W3F1-2007-0059

SUBJECT: Response to Request for Additional Information on Request for Alternative
W3-ISI-004 – Proposed Alternative to Second Interval ISI Examinations
Waterford Steam Electric Station, Unit 3
Docket No. 50-382

**Response to Request for Additional Information (RAI)
for Request for Alternative W3-ISI-004 – Proposed Alternative
to Second Interval ISI Examinations**

Figure 1

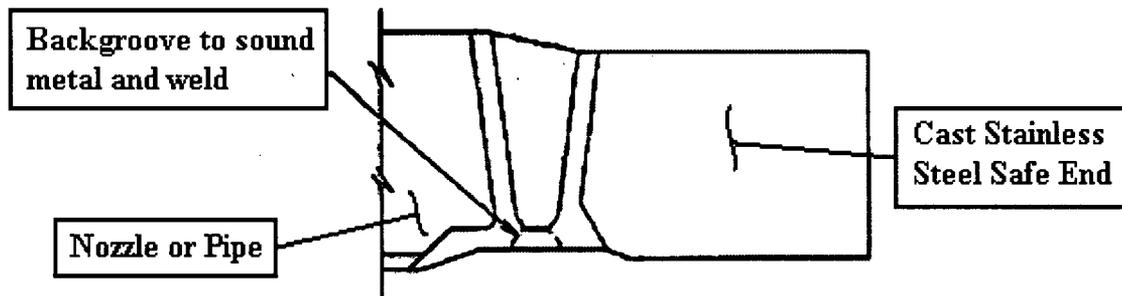
RAI 2 - *As residual stress is as important as operating temperature for flaw initiation and growth, please address the estimated residual stress in the welds and how this level of stress affects susceptibility to primary water stress-corrosion cracking. Please provide weld fabrication details and any documented repairs made to the nozzle welds and any other details which could affect the weld residual stress profile for those welds which examination deferral is requested.*

The root pass design shown in Figure 1 is typical of all seven locations. A weld prep was machined onto the mating surfaces on both components and the Alloy 82 butt weld was performed with a subsequent ID back-groove-and-fill. The design drawing for the Loop 2A RCP discharge DM weld and the Loops 2A and 2B RCP suction DM welds depict butter on the cast stainless steel safe end (Figure 1, weld ID's 11-002, 12-012, and 13-016). The design drawing for the Loop 2B RCP discharge DM weld and the Loops 1B, 2A, and 2B safety injection nozzle DM welds do not depict butter on the cast stainless steel safe end (Figure 2, weld ID's 14-002, 10-008, 12-009, and 14-006). References [3.2], [3.3], [3.4], [3.5]

(Applies to Loop 2A RCP discharge DM weld and the Loops 2A and 2B RCP suction DM welds)
